CITY PLANNING COMMISSION

- A. Negative Declaration
- B. Plan Review of two warehouse/office buildings totaling 17,325 square feet on a portion of 8.6+ vacant acres in the Light Industrial-Review M-1(S)R Zone.

LOCATION: Southwest Corner Raley Boulevard and Vinci Avenue

BUILDING 'A'
 FLOOR PLAN
 ELEVATIONS
 TYPICAL CROSS SECTION
 SECTIONS

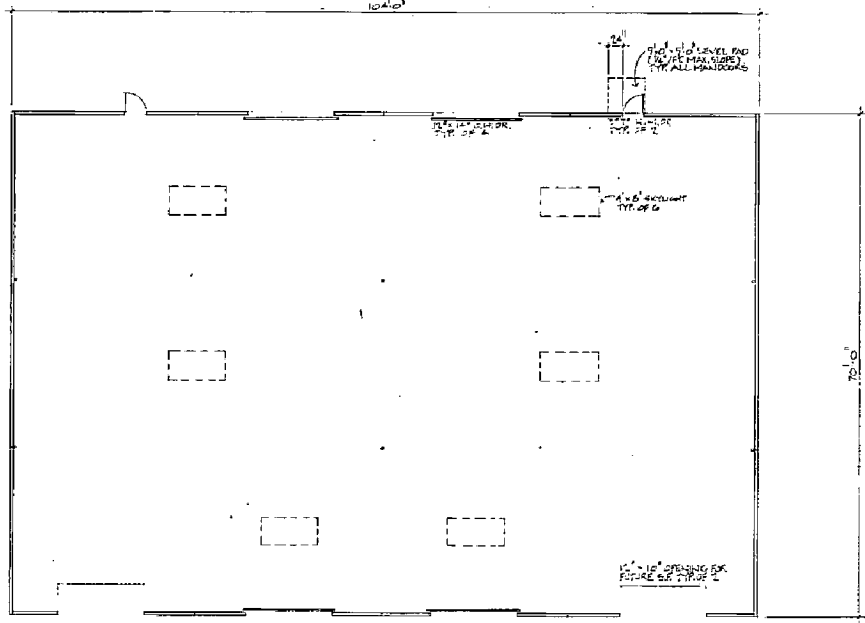
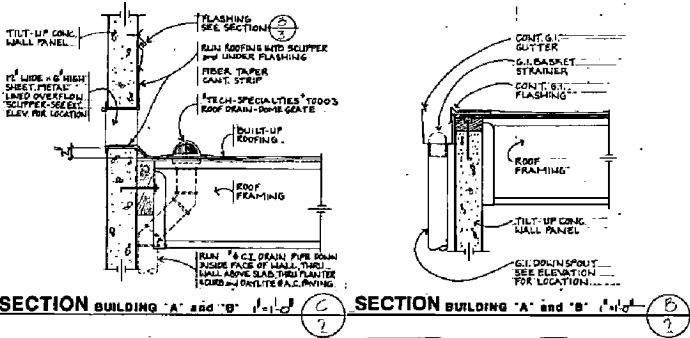
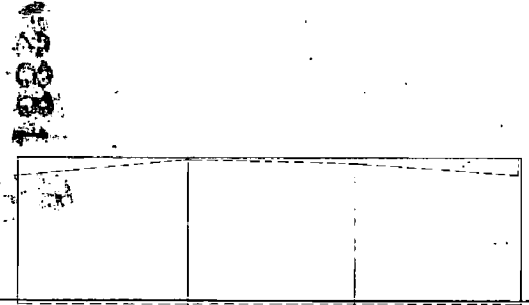
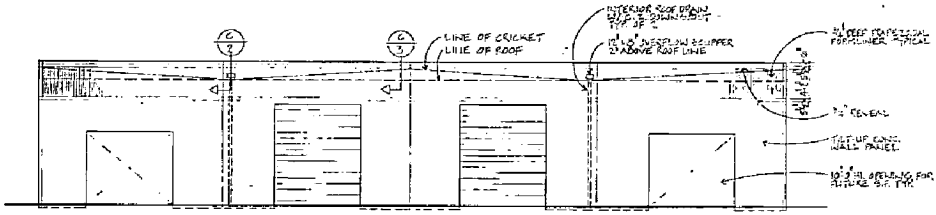
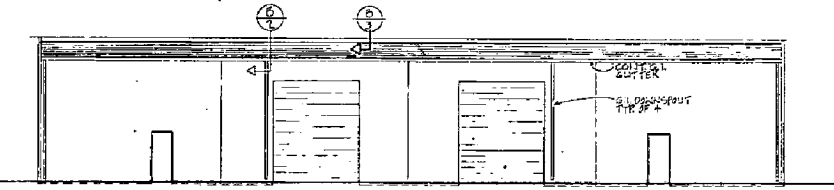
The proposed buildings have loading doors facing Raley Boulevard. Staff does not support the establishment of loading doors facing Raley Boulevard due to unsightliness of metal roll up doors and truck activities facing a major street. On three prior plan reviews, staff recommended, and the Commission approved, buildings with no loading doors facing a major street: Sacramento Security Park (P85-397), approved October 24, 1985, by the Commission; I-80 Industrial Park (P88-057), approved February 25, 1988, by the Commission; and Raley Industrial Park (P89-120), approved May 25, 1989, by the Commission.

In discussions with the applicant, the exterior elevations will have the formliner extended to the Vinci Avenue frontage elevations. Staff has recommended the addition of one or two reveal lines to be painted a contrasting color to accent the building on all four elevations. Final elevations shall be reviewed and approved by the City Planning Director and Design Review Coordinator.

Staff recommends the buildings that have the Raley Boulevard loading doors should be eliminated and replaced with a storefront window system or similar decorative treatment for both buildings.

The applicant could also re-orient the buildings on the pads to have loading doors face north and south and incorporate wing walls to screen the loading doors closest to Raley Boulevard.

2. The applicant shall revise the exterior elevations to the satisfaction of the City's Design Review Coordinator and Planning Director. All proposed colors are to be included in the revised elevations.

LANDSCAPE PLAN

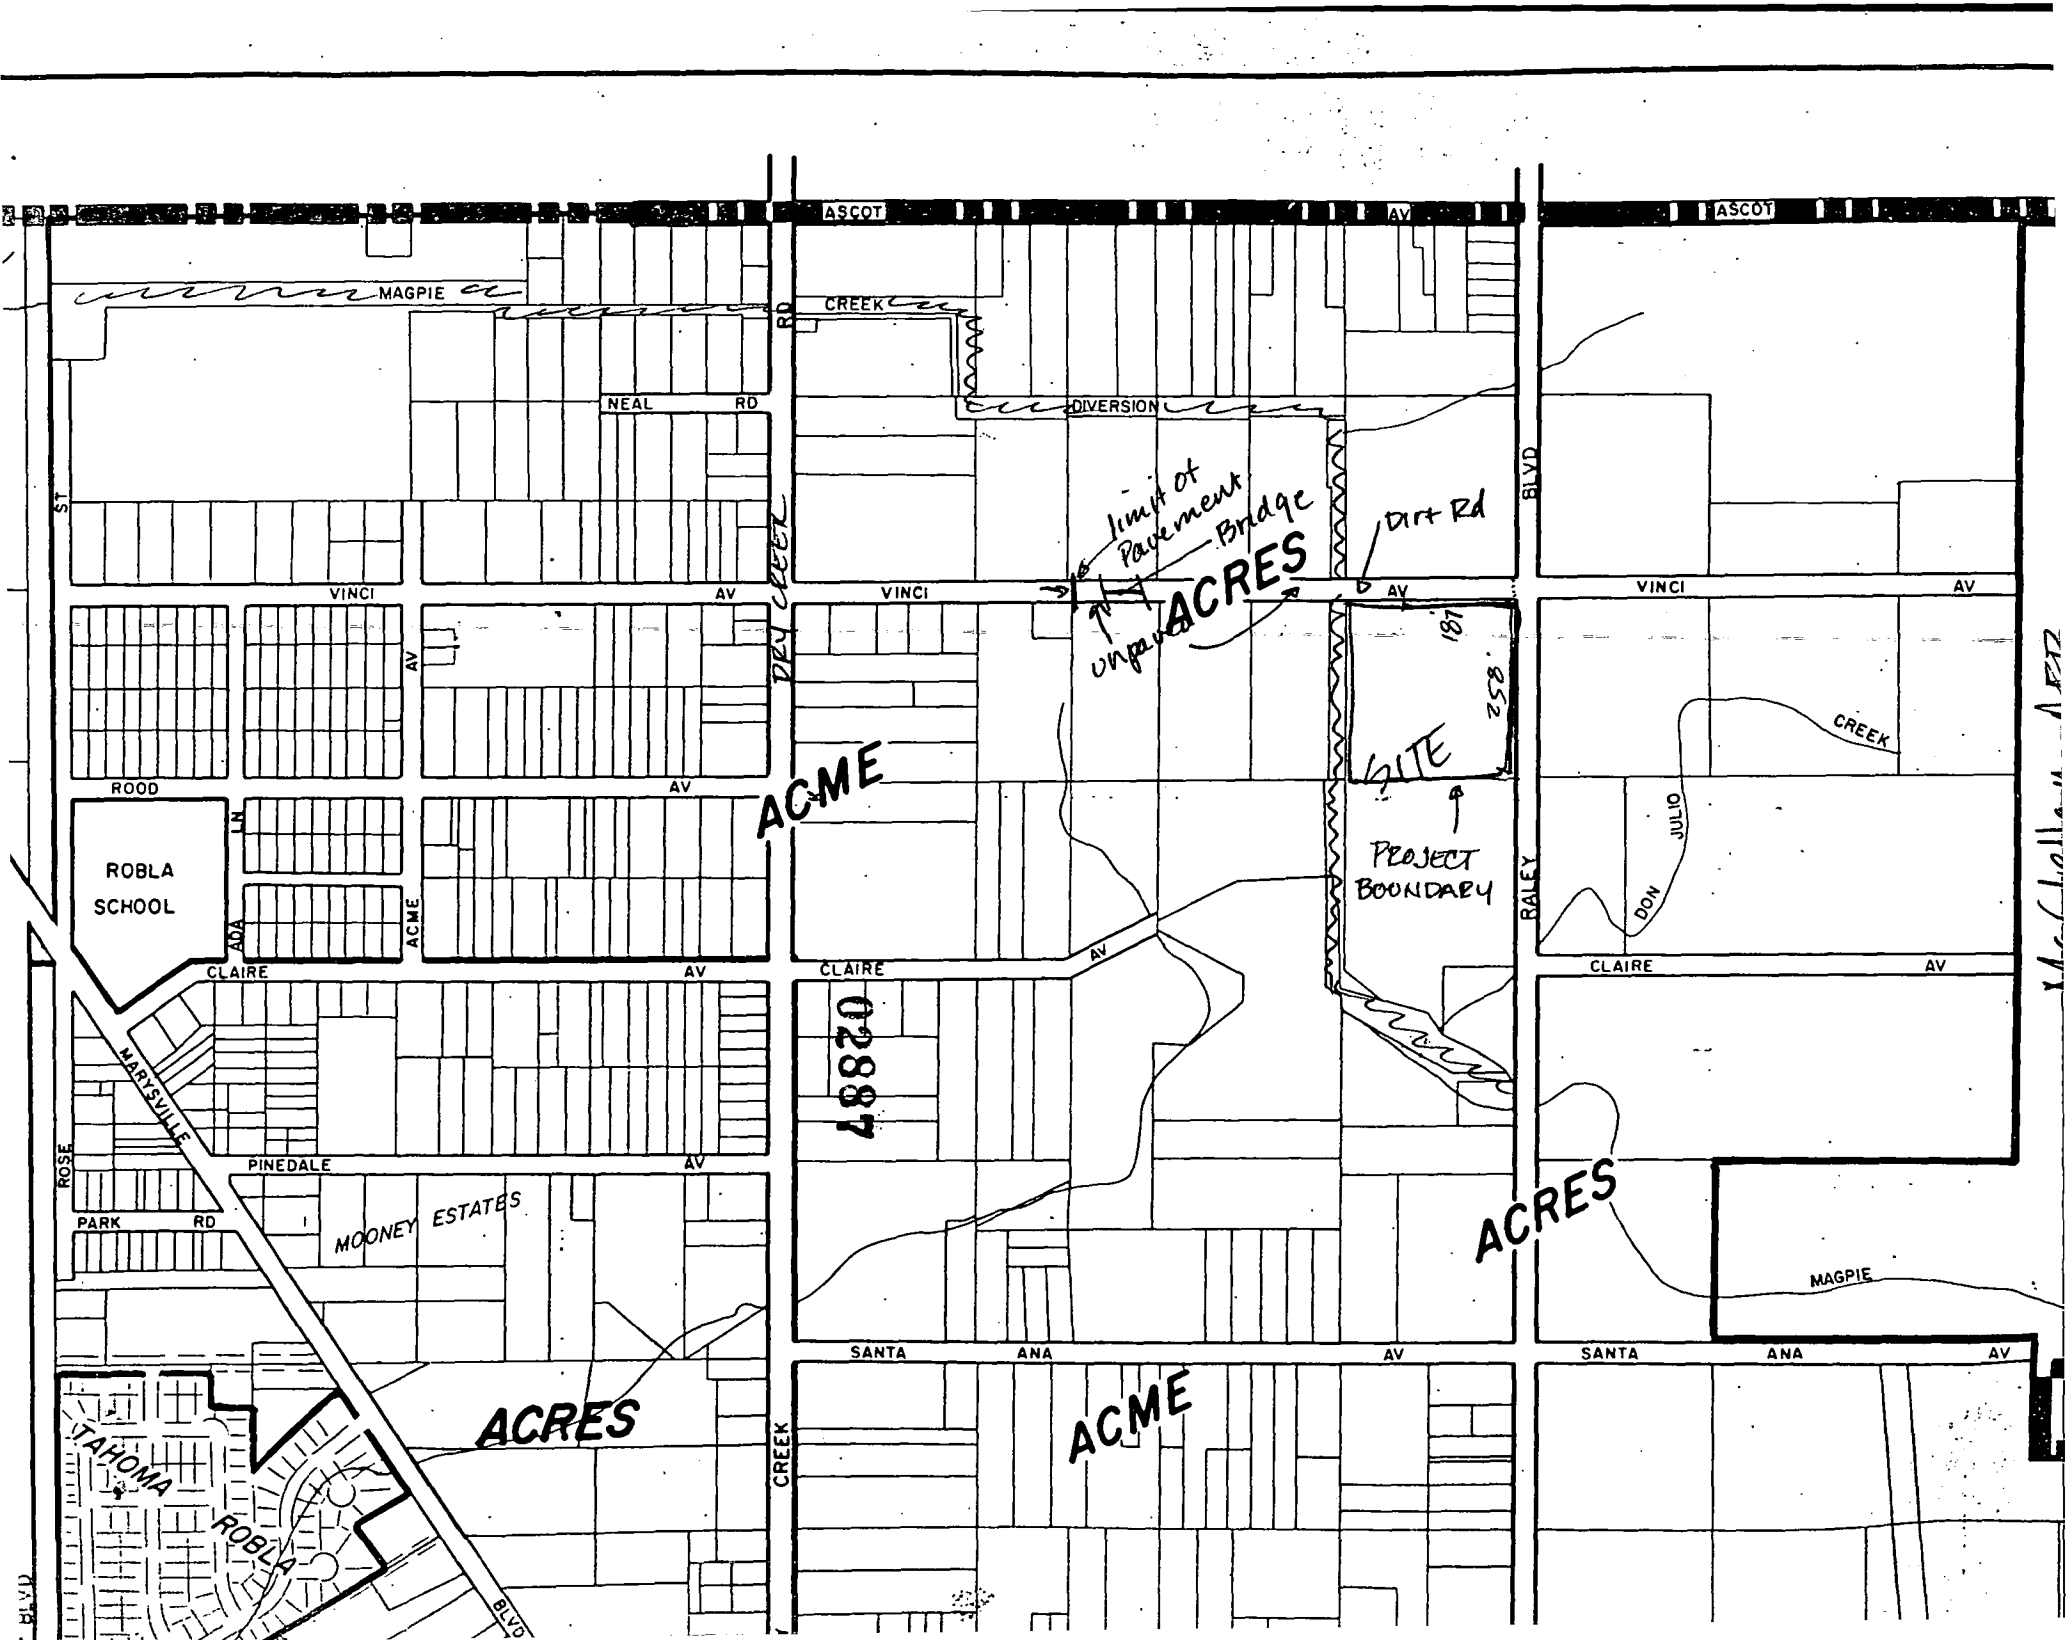
Staff recommends detailed landscaping and irrigation plans be reviewed and approved by the Planning Director prior to issuance of building permits. The applicant is required to comply with the requirements of the City Tree Shading Ordinance for parking and maneuvering areas so that final placement of trees and shrubbery will require further review. Ground cover in the 25 foot landscape setback shall be lawn. No bark mulch will be allowed as shown on the landscape plan in the 25 foot landscape setback area.

Staff notes an absence of planting area adjacent to the buildings. On previous requests, staff has recommended narrow planters with vines planted adjacent to the building or tree wells to provide breaks in the place of the wall's blank facade. The landscape plan should show plantings adjacent to the buildings.

1. The applicant shall prepare a revised site plan, detailed landscaping and irrigation plans for review and approval by the Planning Director prior to issuance of building permits. Plans shall reflect the treatments discussed in this report.
